# Springsure Creek Coal Mine Project

## Response to comments on final EIS

### Department of Agriculture, Fisheries and Forestry

### Department of Natural Resources and Mines

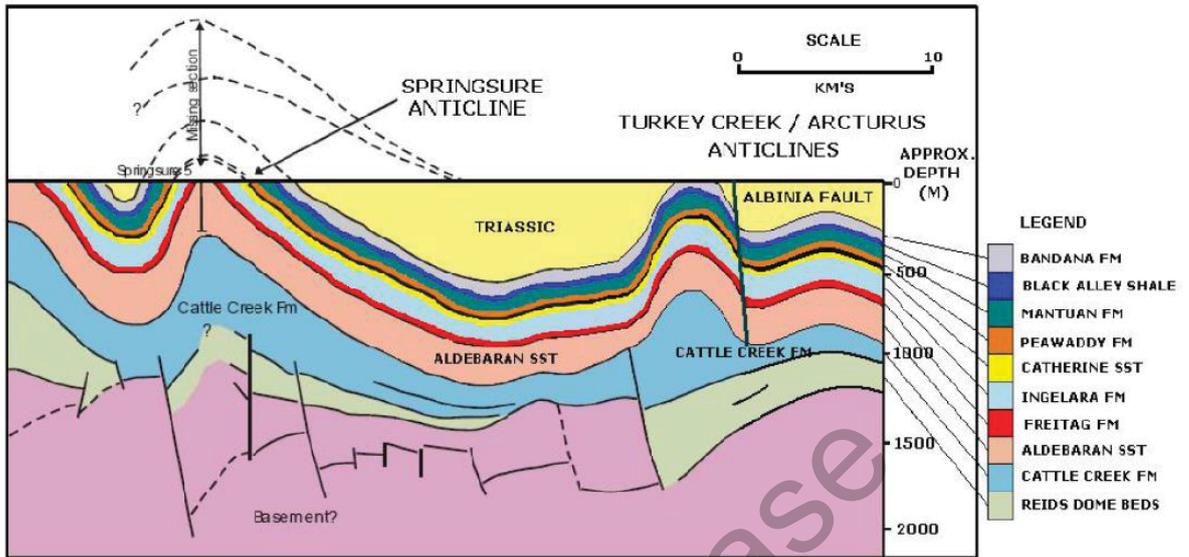
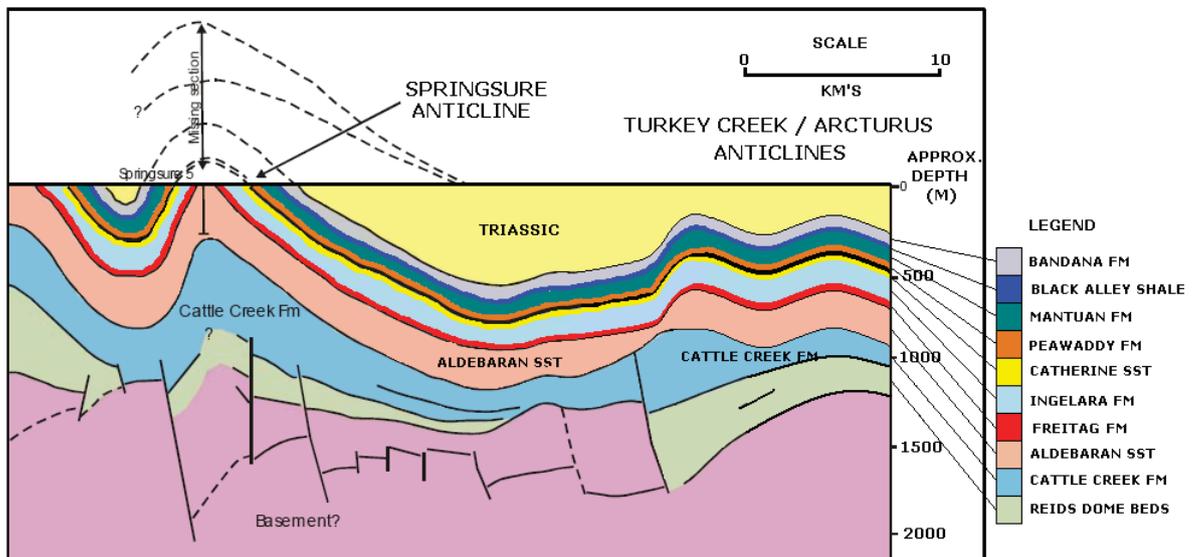
The Albinia Fault shown in Figure 1 is probably an indication of Aries 2 Seam thinning rather than being a distinct fault.

Further to the commentary above, I would add that the figure above shows very clearly that the Late Permian Bandanna Formation crops at surface just west of the Albinia Fault, which itself has facilitated an uplift and outcropping of the Permian strata. This clearly flies in the face of all evidence collected to date and most, if not all, interpretations of the geology of the area. We see nothing but Tertiary basalts and sediments at surface at Springsure Creek, in addition, there is always Rewan Formation found between the tertiary and Permian strata.

In short, I cannot account for the section and the interpretation of the geology it represents and I confirm that I cannot find a copy of the section on the network.

The following is the figure that I would propose we replace the current figure with. It clearly reflects the current interpretation that major faults within and adjacent to the tenure area are basement faults and do not intersect the Bandanna Formation and above. It also better reflects the strata thicknesses and depths that we have seen in all drilling to date in the Springsure Creek project area.
